Agenda
Village of Arlington Heights
Design Commission
Buechner Room, 1st Floor

MINUTES OF
THE VILLAGE OF ARLINGTON HEIGHTS
DESIGN COMMISSION MEETING
HELD AT THE ARLINGTON HEIGHTS MUNICIPAL BUILDING
33 S. ARLINGTON HEIGHTS RD.
MARCH 14, 2017

Department: Planning & Community Development

4E
A200 FRONT ELEVATION

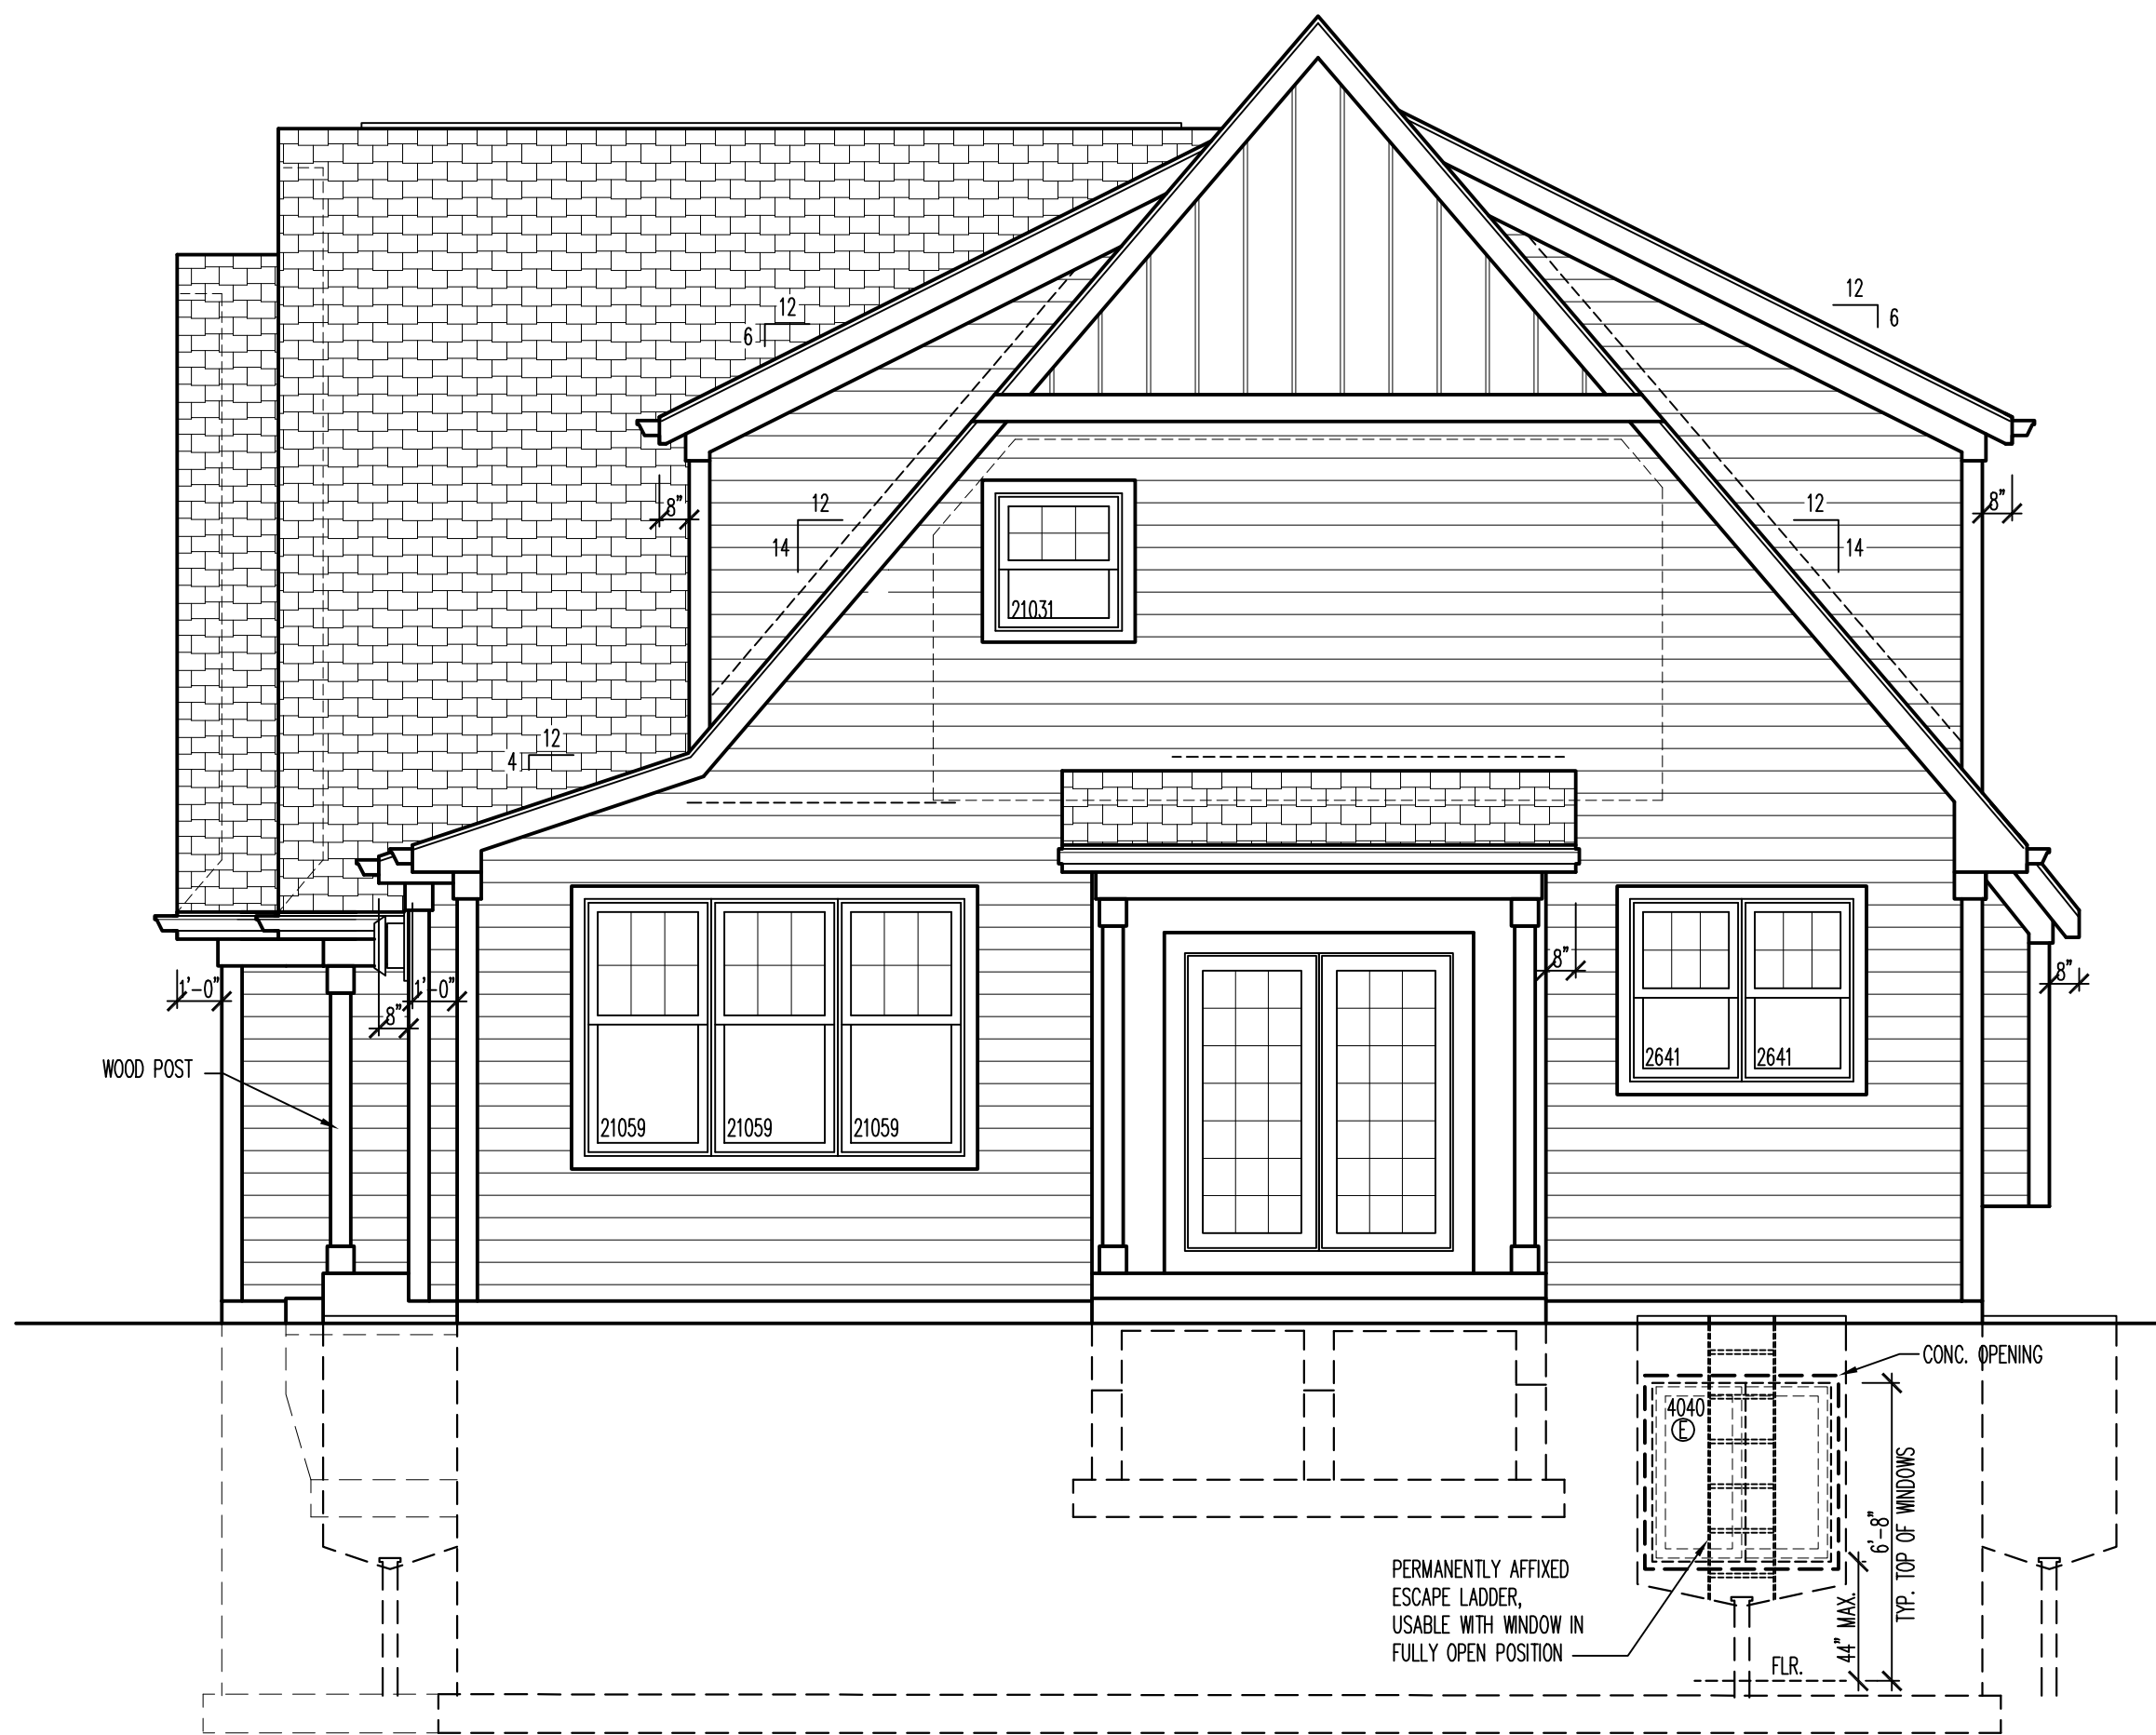
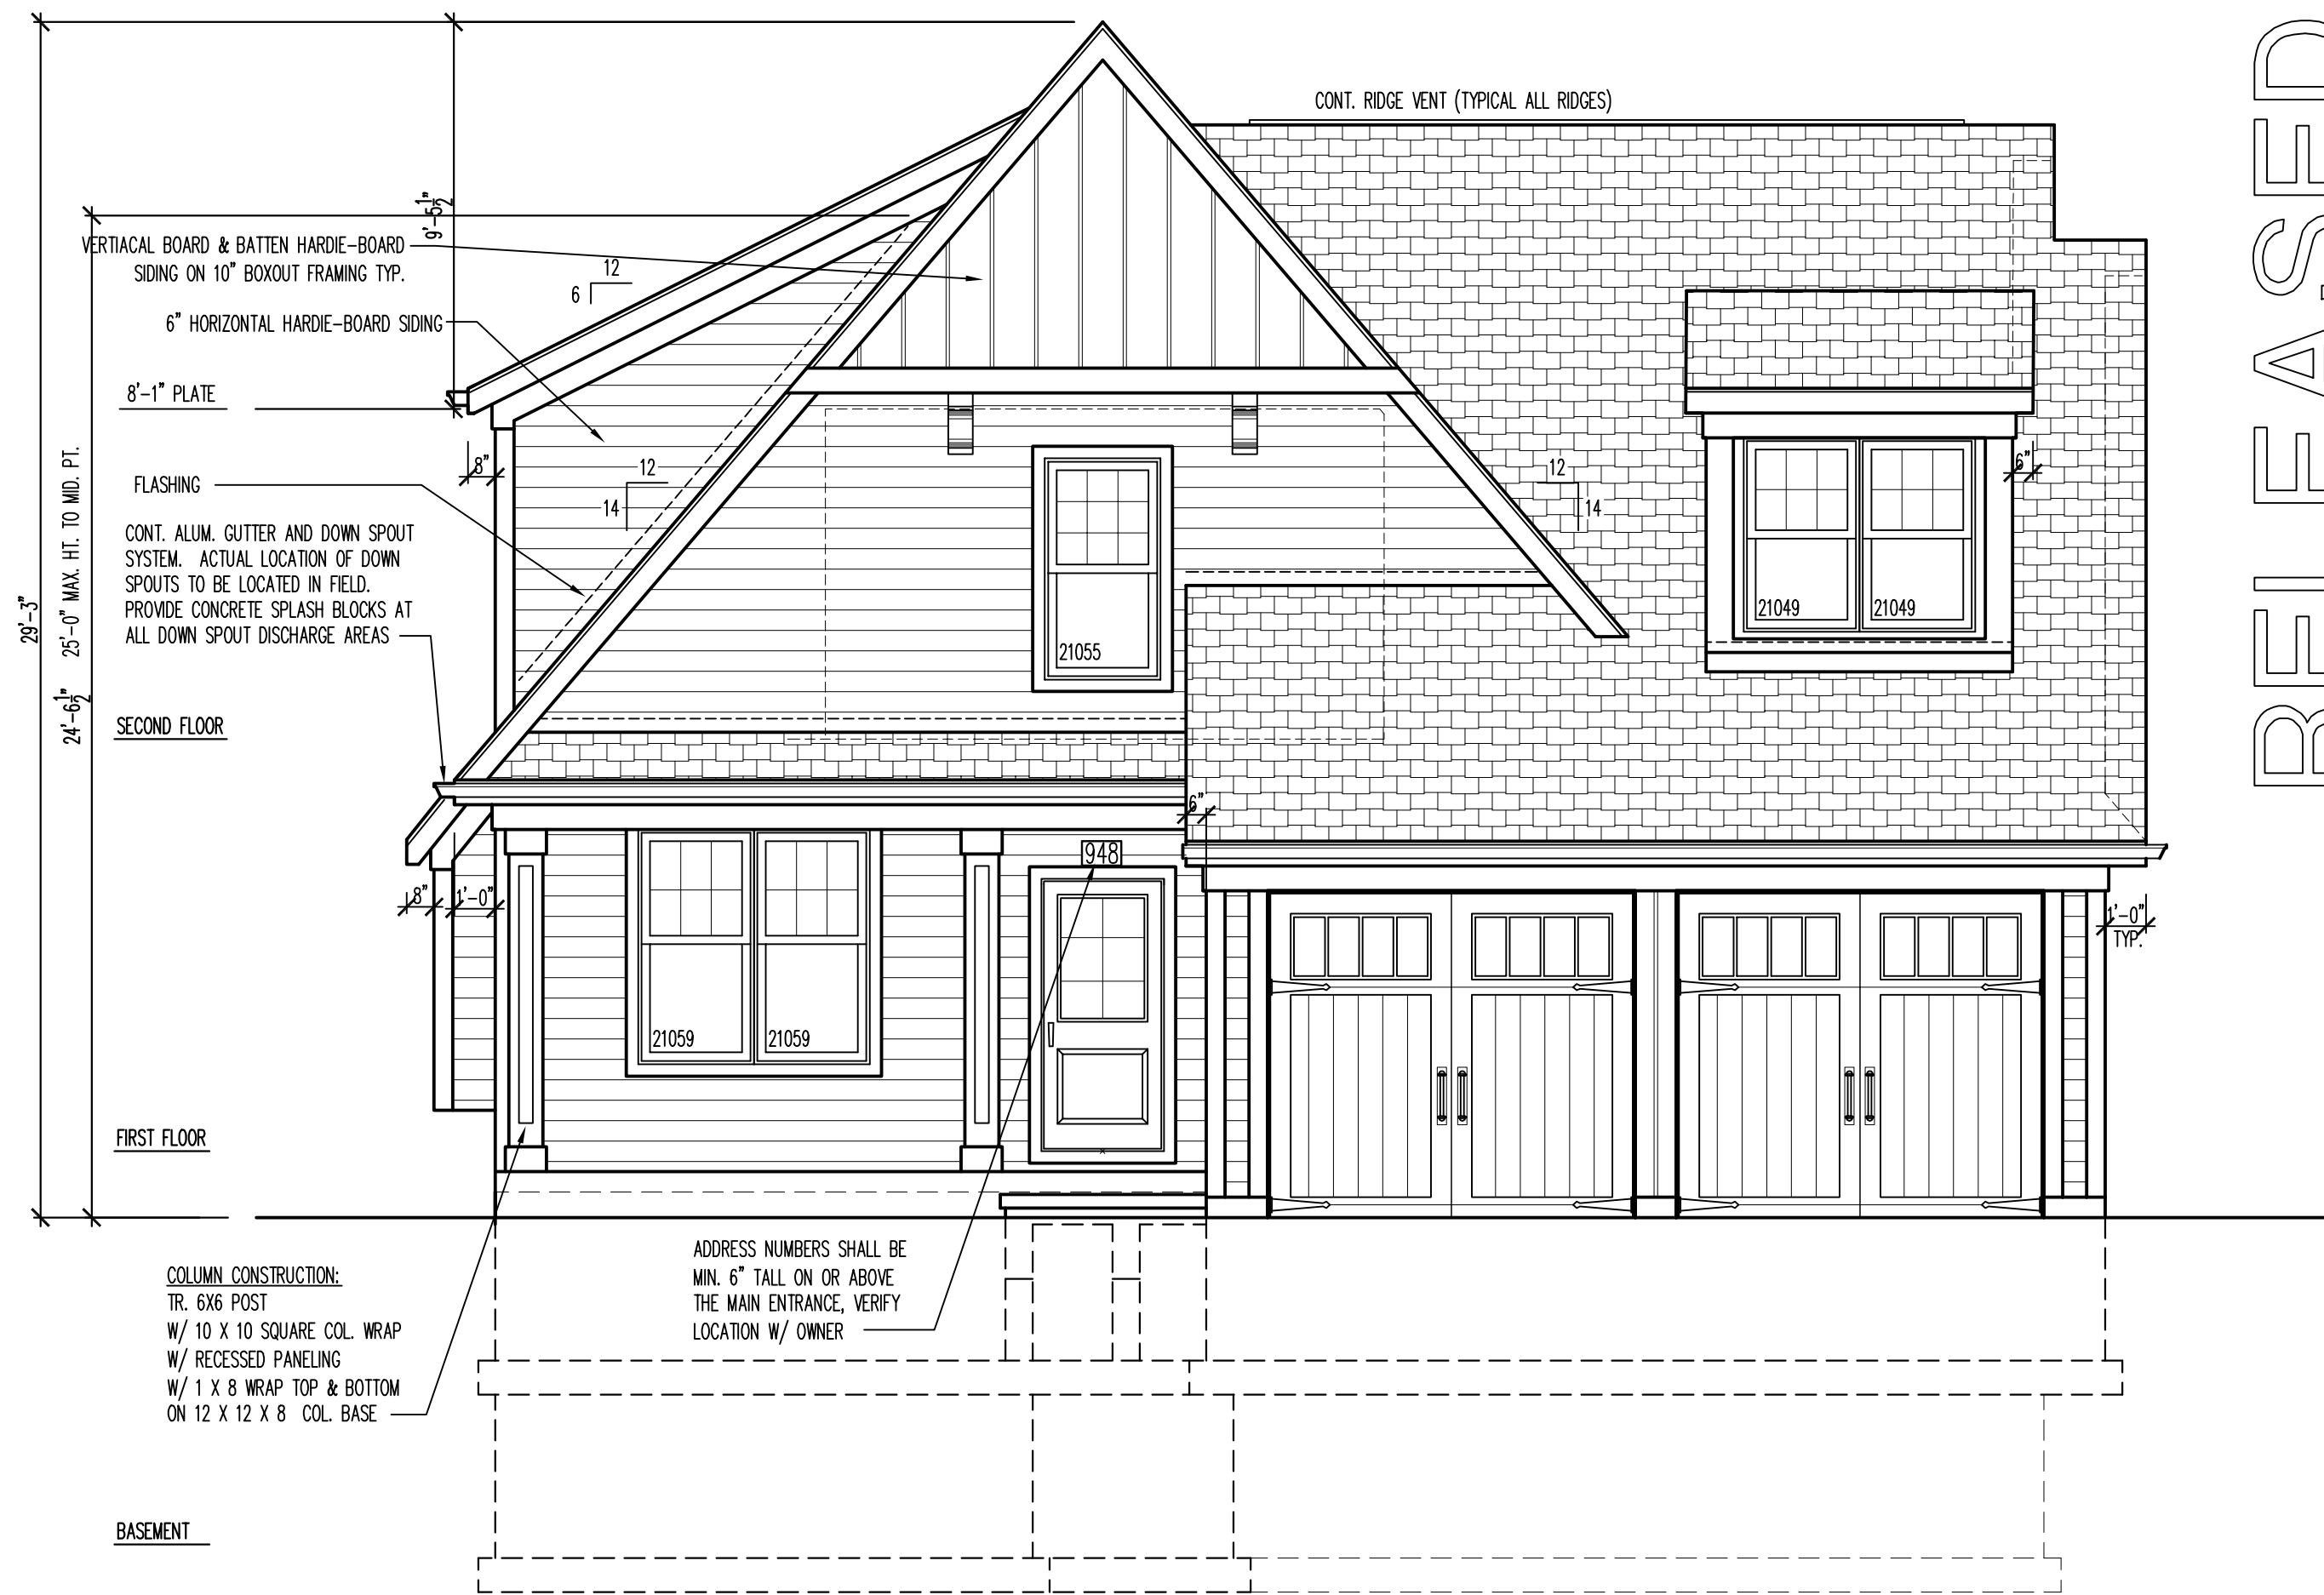
It is recommended that the Design Commission approve the proposed architectural design for the new (teardown) single-family home to be located at 948 N. Fernandez Avenue. This recommendation is subject to compliance with the architectural plans received 2/24/17, Design Commission recommendations, compliance with all applicable Federal, State, and Village codes regulations and policies, the issuance of all required permits, and the following:

1. Recess the garage a few feet, and change the single window above front entrance to a double window.
2. This review deals with architectural design only and should not be construed to be an approval of, or to have any other impact on, any other zoning and/or land use issues or decisions that stem from zoning, building, signage or any other reviews. In addition to the normal technical review, permit drawings will be reviewed for consistency with the Design Commission and any other Commission or Board approval conditions. It is the architect/homeowner/builder's responsibility to comply with the Design Commission approval and ensure that building permit plans comply with all zoning code, building permit and signage requirements.
3. Compliance with all applicable Federal, State, and Village codes, regulations and policies.

1 EXISTING CONTEXT ELEVATIONS
1/8" = 1'-0"

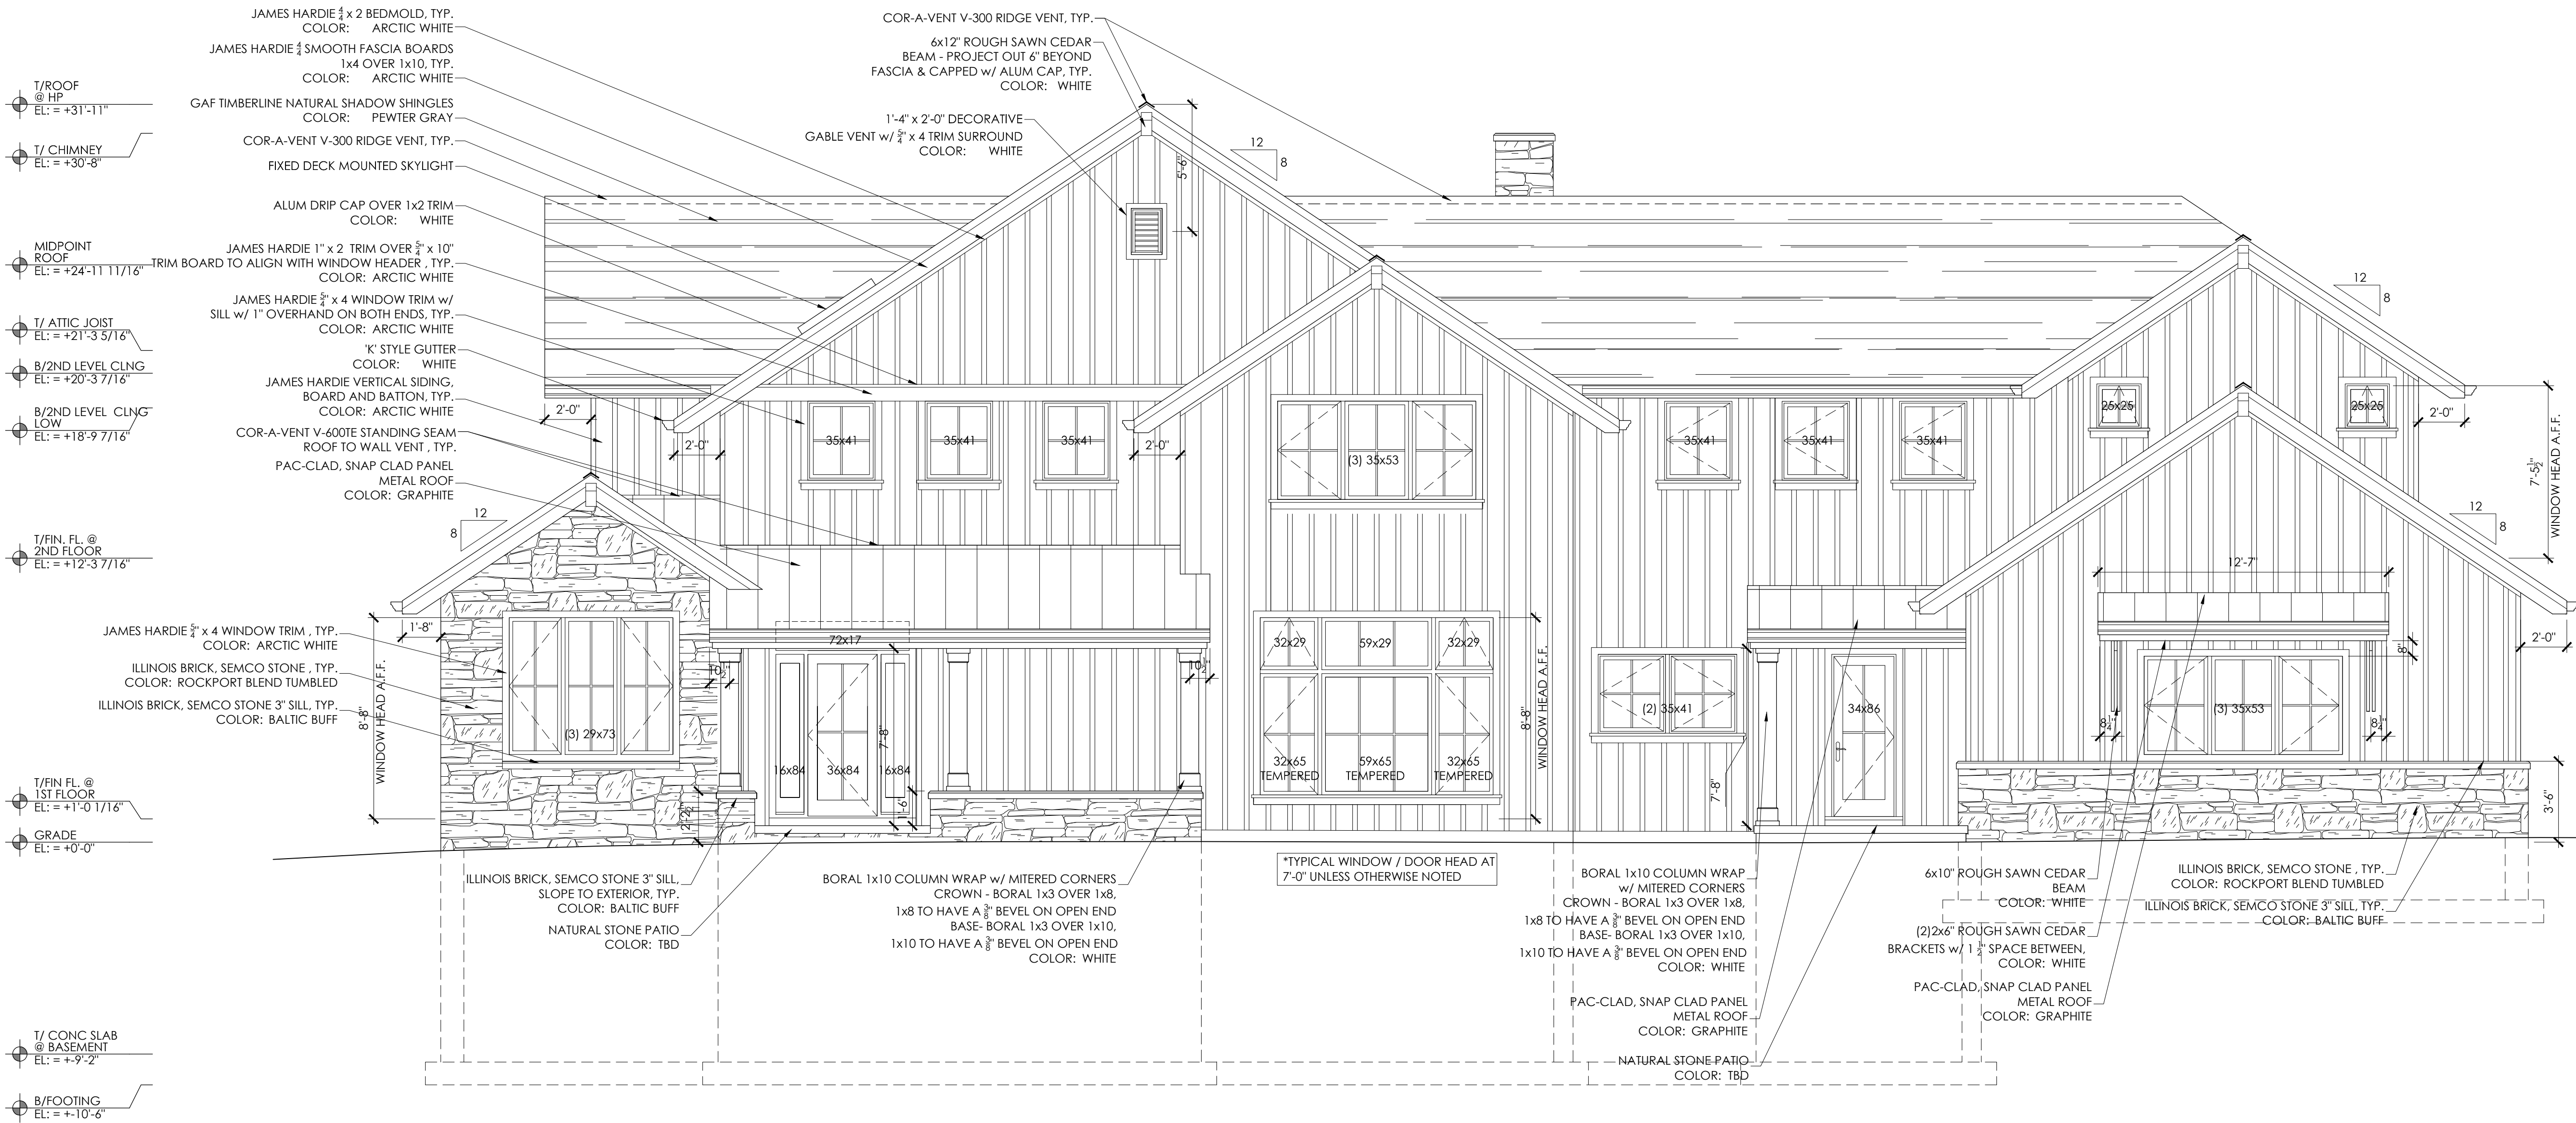
Overall, the proposed design is nicely done with a contemporary farmhouse style. The white board and batten siding is one of the defining characteristics of the design, and this is generally a very nice detail. However, due to the size of the home, there is a large amount of board and batten siding, so it is recommended that other materials be added to break up the amount of board and batten siding. The garage has a stone base on the right side of the front elevation that has a very nice appearance, but the full wall of stone on the single story gable on the left side of the elevation seems random. For a more balanced composition, it is recommended that stone be added on the gable in the center of the front elevation, possibly up to the sill of the second floor windows, and the full stone wall on the left side be reduced to match the garage. Another suggestion to break up the amount of board and batten siding and add interest to the design would be to combine it with other siding styles, such as horizontal siding on the first floor with board and batten siding above.

It is recommended that the Design Commission approve the proposed new single-family residence to be located at 828 N. Forrest Lane. This recommendation is subject to compliance with the architectural plans dated 2/24/17 and received 3/3/17, and the following:

1. Revise the exterior materials to include a better balance of stone and siding. Consider combining horizontal siding with the board and batten siding for more variety.
